CHANGE ORDER REQUEST FORM

PROJECT Henry Smith Road Improvements Project

No. 0003

Description: Change order 0003 captures adjustments made for mitered end sections and drainage changes.

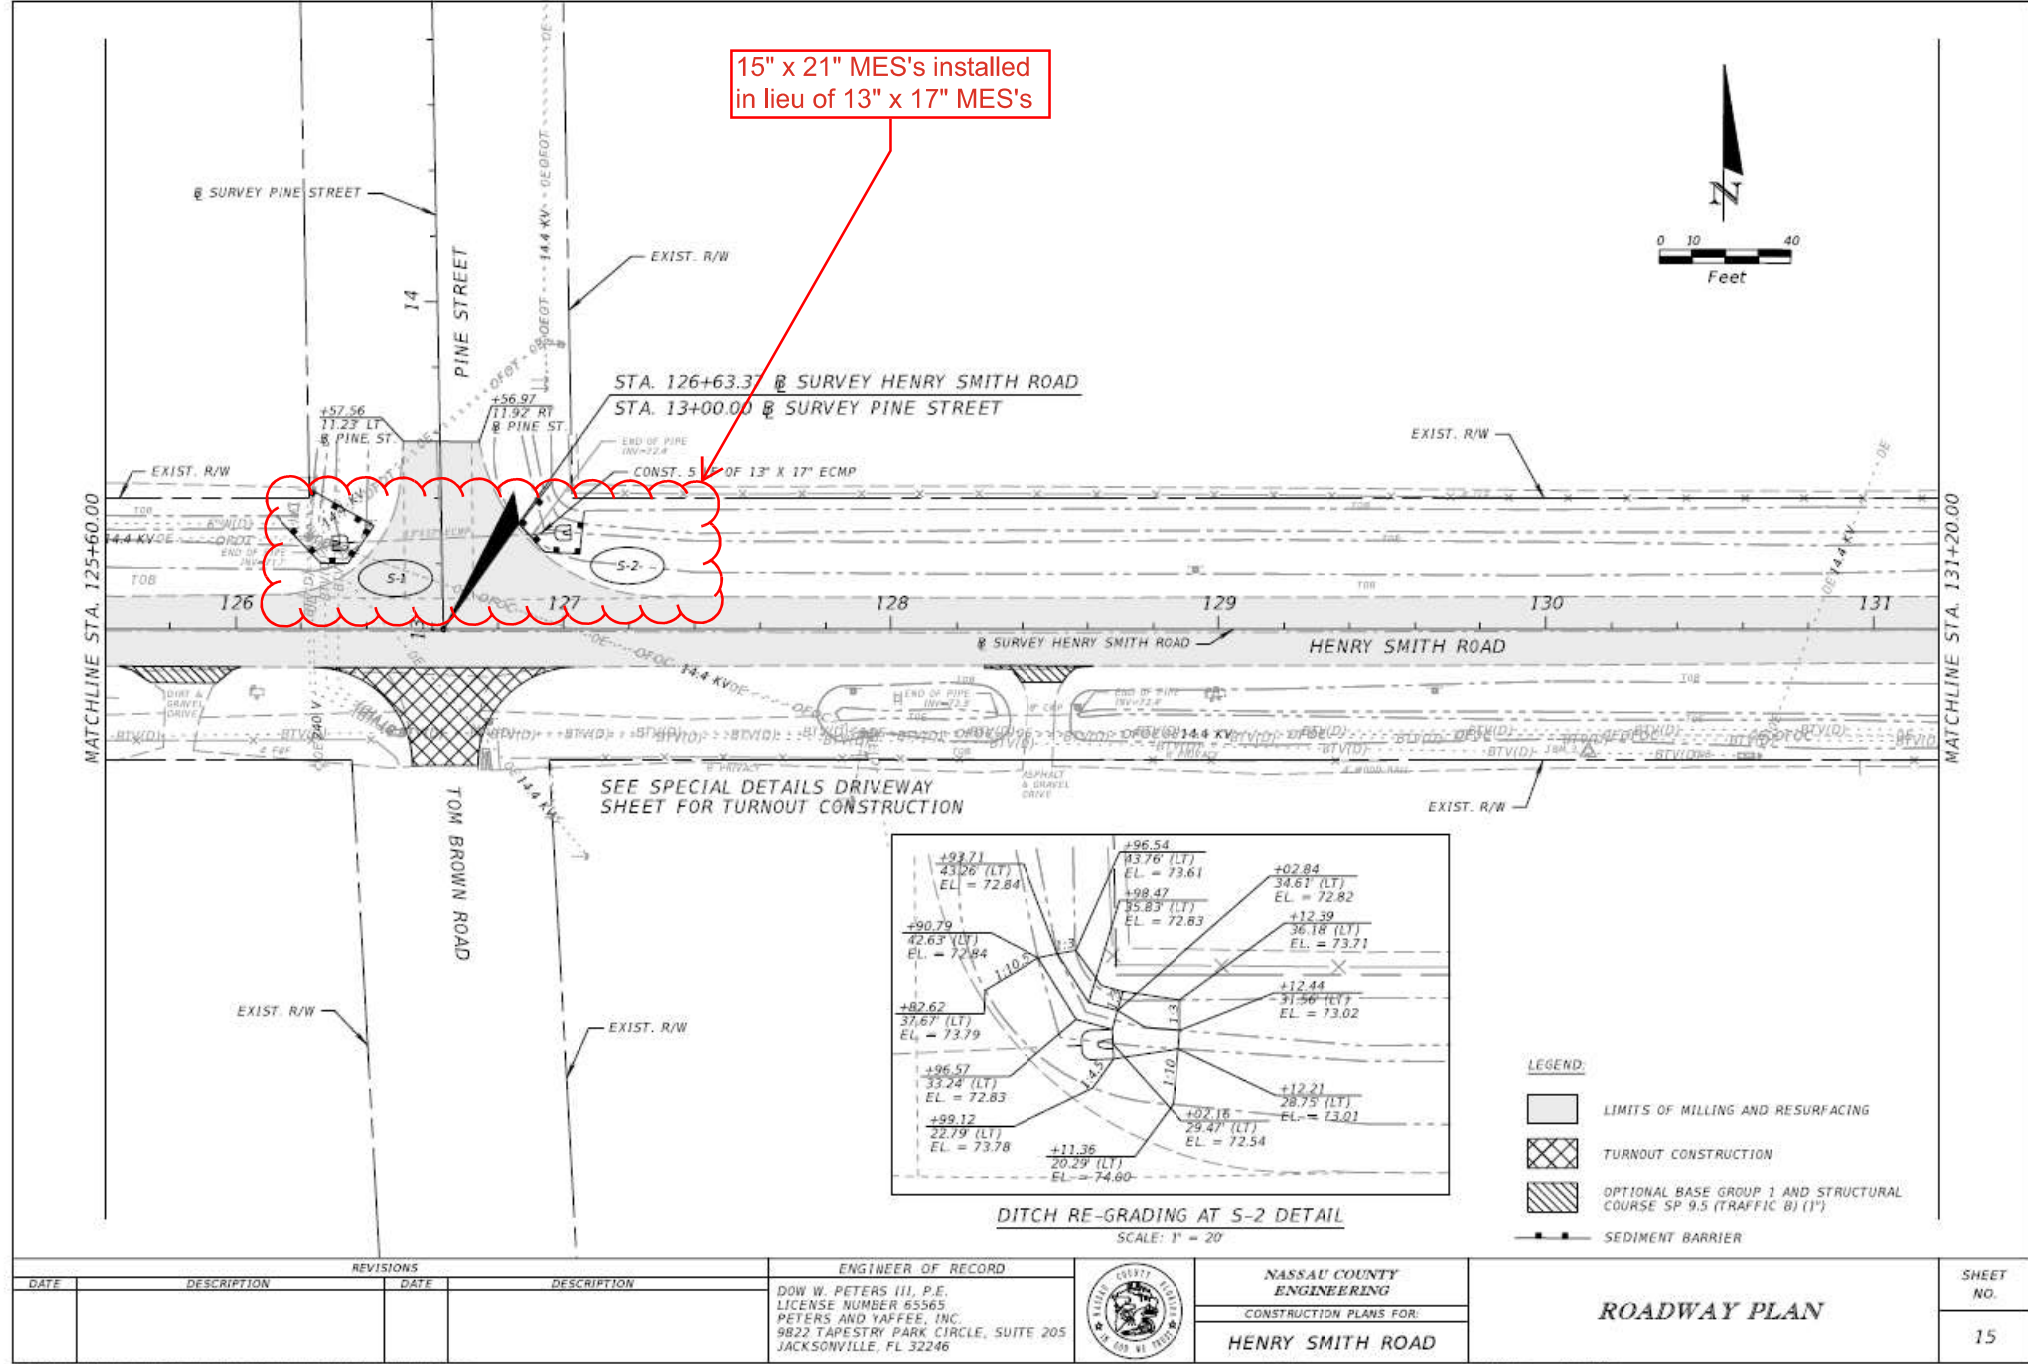
- The Construction Plans call for the installation of 13" x 17" Elliptical Corrugated Metal Pipe (ECMP) Mitered End Sections (MES) at S-1 (Station 13+26.91 LT, Pine Street) and S-2 (13+28.56 RT, Pine Street). The existing pipe at this location was in fact 15" x 21" ECMP not 13" x 17" ECMP as noted in the plans. 15" x 21" ECMP MES's were installed in lieu of the 13" x 17" ECMP MES's detailed in the plans.

- Price increase: \$2,738.00
- The Construction Plans call for 15" x 21" ECMP MES's at stations 133+90.69 and 134+29.80 RT. The existing 15" x 21" pipe was severely degraded and replaced with 18" High-Density Polyethylene (HDPE) pipe by Nassau County. As a result, 18" CMP MES's were installed in lieu of the 15" x 21" ECMP MES's detailed in the plans

- Net zero price change
- The Construction Plans call for 15" Corrugated Metal Pipe (CMP) MES's at stations 170+61.2 and 171+00 RT. The existing 15" pipe was severely degraded and replaced with 18" HDPE pipe by Nassau County. As a result, 18" CMP MES's were installed in lieu of the 15" CMP MES's detailed in the plans.

- Price increase: \$1,258.00
- The Construction Plans call for 15" Reinforced Concrete Pipe (RCP) MES's at stations 172+47.2 and 172+98.73 RT. The existing pipe was in fact 15" Polyvinyl Chloride (PVC) instead of 15" RCP so 15" CMP MES's were installed in lieu of the 15" RCP MES's detailed in the plans

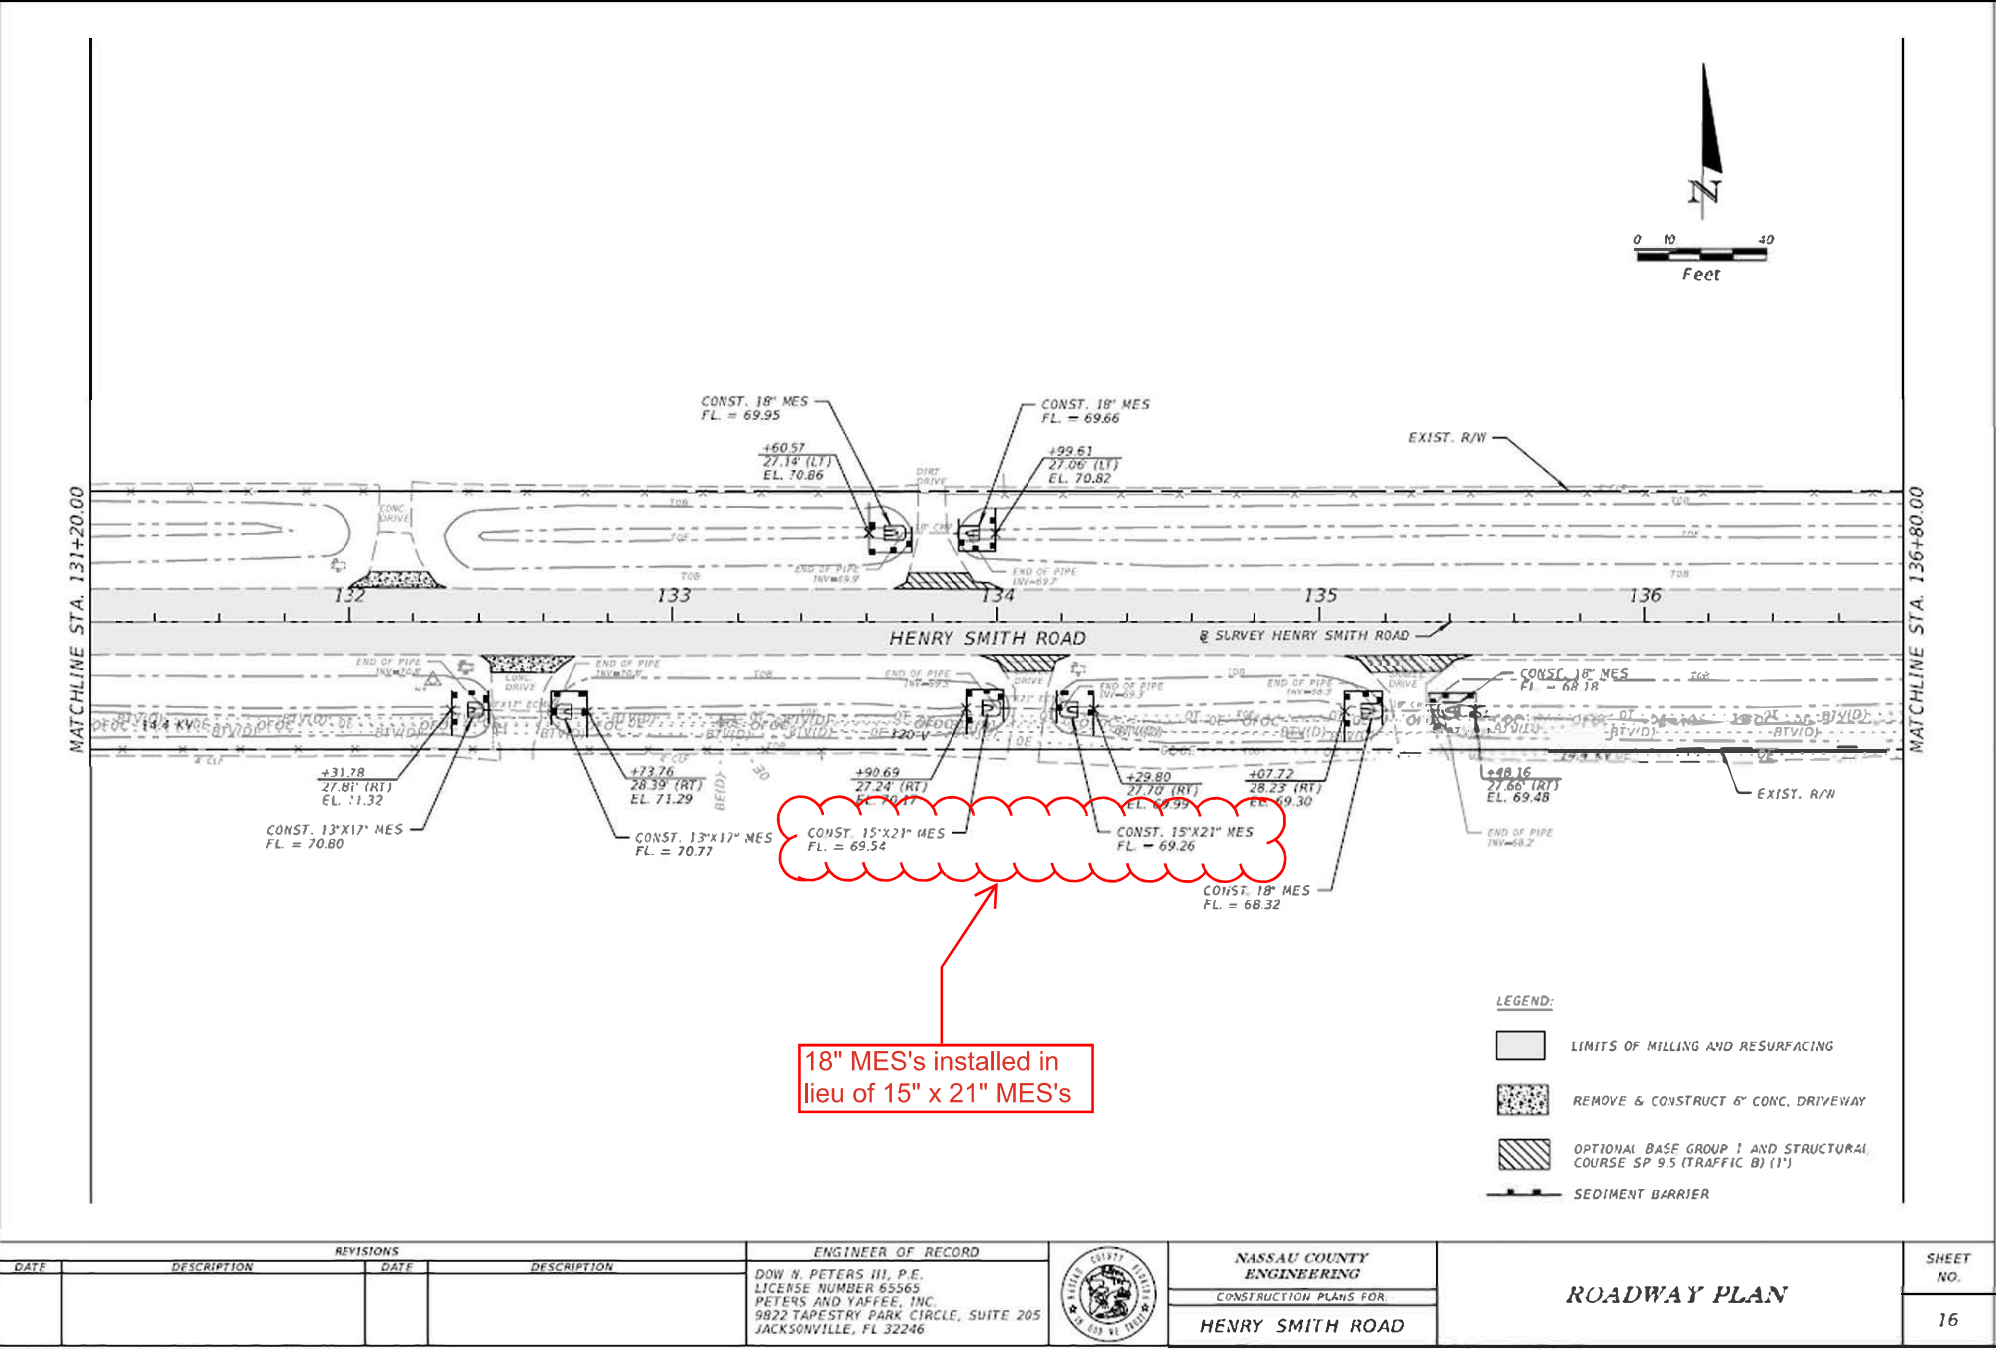
- The Construction Plans call for 5LF of 24" RCP at MES S-5 (Station 175+48.66 LT). The existing 24" CMP that the proposed 24" RCP was supposed to connect to was severely degraded. 3LF of the existing 24" CMP was removed and replaced with 3LF of 24" RCP. The new total of RCP at the subject location increased from 5LF to 8LF.
 - Price increase: \$2,058.00
